Central Valley Regional Water Quality Control Board

NOTICE OF APPLICABILITY (NOA), WATER QUALITY ORDER 2014-0153-DWQ-R5180, CALIFORNIA DEPARTMENT OF TRANSPORTATION – DUNSMUIR GRADE FACILITY, SISKIYOU COUNTY

INSPECTION REPORT

Frame 1, Leach Field

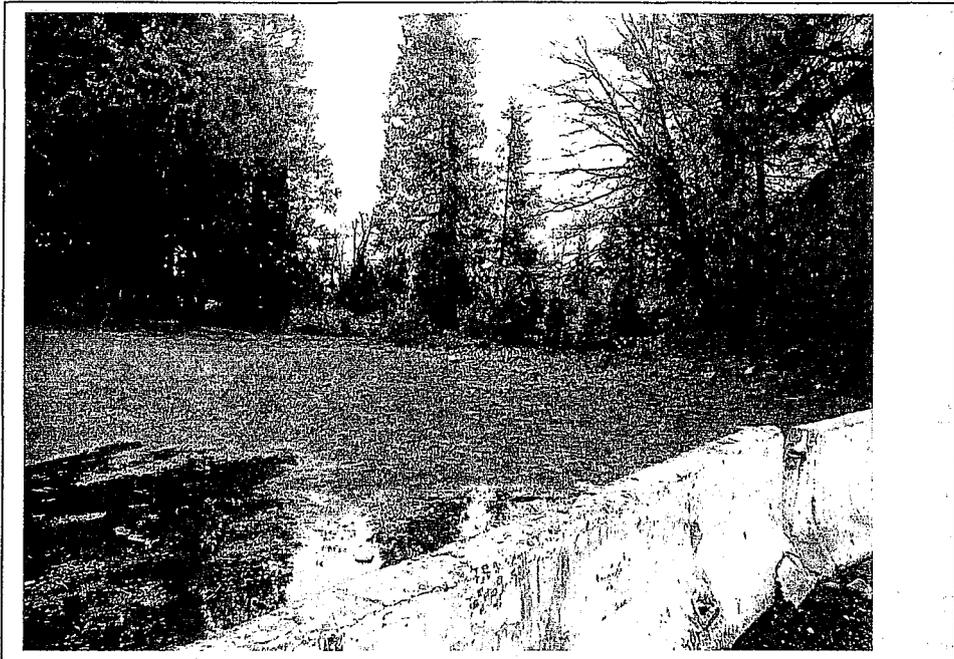
We arrived on-site at about 10:00 AM. Weather was cool and cloudy, following recent heavy rains. Bob Weber, P.E., CalTrans Civil Engineer, gave us an overall facility tour and drawings of the proposed upgrades. We first inspected the existing OWTS leach field, and nearby culvert and gully; see enclosed Photographs; Frame 1 shows the leach field, an unpaved area south of concrete K-rails. Frame 2 shows the gully within 50 feet of the leach field. Note isolated standing water in the channel, and the fine-grained native soils. I asked Bob for further information on local percolation rates, and thickness and hydraulic conditions of the soils above bedrock. He agreed to provide the further information.

An ephemeral drainage is within 50 feet of the proposed upgrade, nominally prohibited in General Order 2014-0153. However, surface water shows no evidence of eutrophication or stressed vegetation, and the Discharger has operated the existing OWTS for several decades. Therefore, the General Order should still apply in the case; however the Monitoring and Reporting Program (MRP) should specify appropriate wet season inspections of the drainage.

Frame 3, Inspection Bay

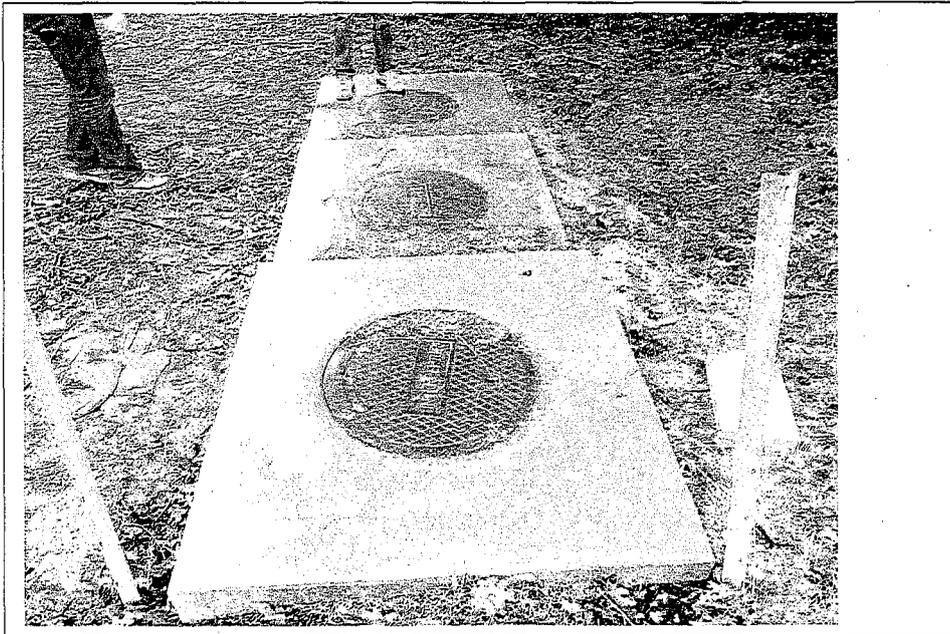
We next inspected the truck inspection bays and related wastewater management system. Laurie Hurt, California Highway Patrol (CHP) Commercial Vehicle Inspection Specialist, gave us a tour of the inspection bays; see Frame 3. Based on her description, slot drains in the bays collect largely snow-melt that falls from trucks, and floor rinse-water. This water can include minor amounts of petroleum grease and diesel fuel. I asked Laurie about the potential risk of fuel leaks and other hazardous wastes entering the slot drains. CHP staff contains visible petroleum leaks with plastic pans and sorbent materials on the bay floor. If trucks have

suspected hazardous materials, CHP staff inspects them outside the building. Staff washes no trucks in the inspection bays, rinses floors only with water, and does not add surfactants.

Frame 4, Oil/Water Separator

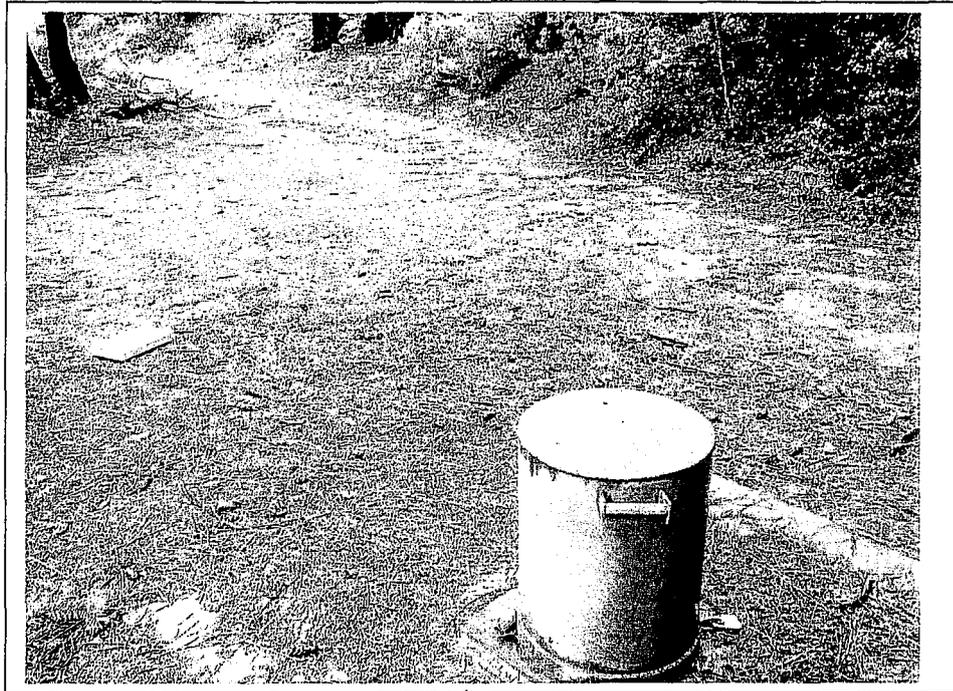
Sub-grade piping carries water from the inspection bays to a three-celled oil/water separator; see Frame 4. Filtrate from the separator discharges to a small leach field, separate from OWTS leach field.

Flow through the oil/water separator **shall not exceed 600 gallons/day**. Discharges from the leach field of the oil/water separator **shall not degrade beneficial uses of underlying groundwater**. In the annual report, the Discharger shall assess potential for impacts to groundwater from the oil/water separator, and recommend further action, as appropriate. Because proposed flow rates are less than 20,000 gpd, Attachment 1 of the General Order requires no nitrate effluent limit.
